STANNAH LIFTS LTD

**TECHNICAL BULLETIN****INFORMATION ONLY**

**For the Attention of :** Installers, Testers, Trade Customers, Training Dept,**Date :** 15/10/09**Product :** System 21 Traction Passenger Lifts**Subject :** Changes to Tension Device Mounting Arrangement.**Status :** Product Update - Information only**Pages :** 2

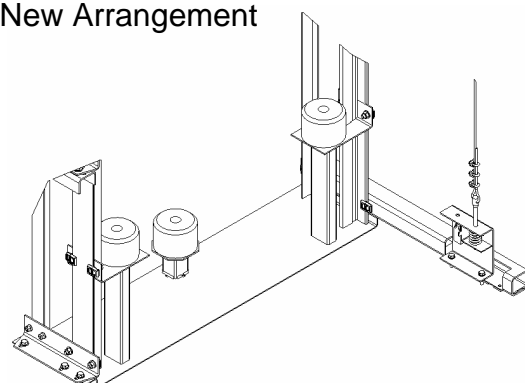
The mounting arrangement for the lower rope tension device has been modified to remove the need to drill the pit floor.

The new arrangement consists of a fabricated channel which clips to the car and counterweight guide rails. It is also secured to the guide baseplate, replacing the guide bracket angle (see below).

Old Arrangement

New Arrangement

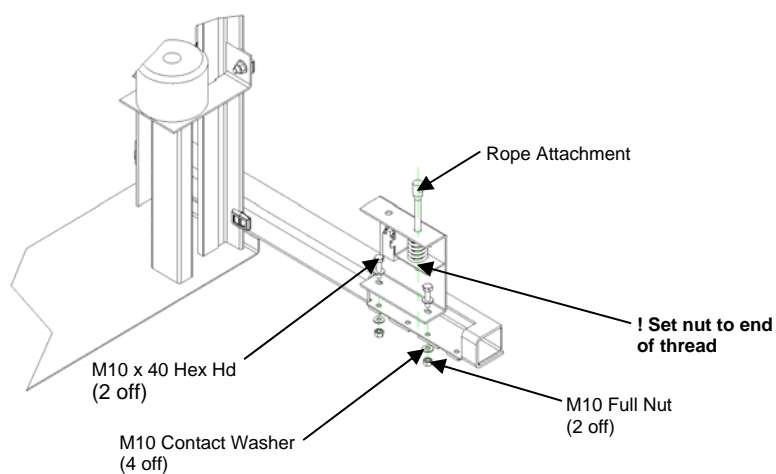
The fabricated channel should be positioned on the guide corresponding with the overspeed governor (i.e. the guide furthest from the entrance when entering the pit). It is secured using the same guide clips and fixings previously used to secure the guide bracket angle.

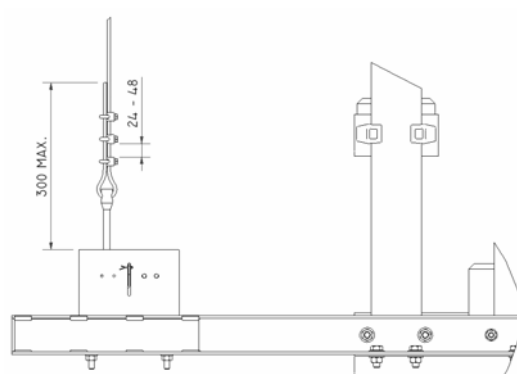
The lower tension device should now be mounted as shown below, ensuring that the rope attachment is central to the cut out in the channel.

When attaching the rope to the lower tension device, it is important to observe the following dimensions to ensure clearances are maintained when the lift has over-travelled the bottom floor.
